Access Compliance Report

Public Rights-of-Way

(Pedestrian Signals)

Intersection ID: N/A	Main Street:	Cross Street: N/A	Location: N/A
ADA ID: 28B8F5F5F8E0	Signal Type: Two Push Buttons-Non APS	Overall Compliance: No	Severity Score: BTN 1:N/A BTN 2: N/A No BTN: N/A
Codes/Mitigation Info/Possible Solution		Field Measurements/Component Compliance

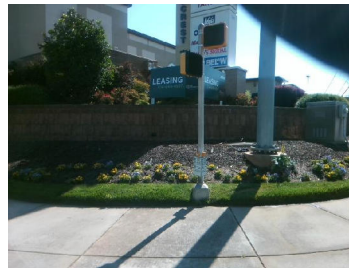
PROW/ADA: TMUTCD 4e.08, R404.2, R406.2

Yes	B 1 Clear Xing Direction?	ClearlyMarked	Yes	B 2 Clear Xing Direction?	ClearlyMarked
	B 1 Crossing Direction	To S		B 2 Crossing Direction	To W
Yes	B 1 DistanceTo XWalk (in)	0.0	Yes	B 2 DistanceTo XWalk (in)	36.0
No	B 1 DistanceTo Curb (in)	172.0	No	B 2 DistanceTo Curb (in)	172.0
Yes	B 1 Diameter (in)	2.0	Yes	B 2 Diameter (in)	2.0

Possible Solutions: Replace Signal Push Button With APS Button on New Post. Remove & Relocate Sign.
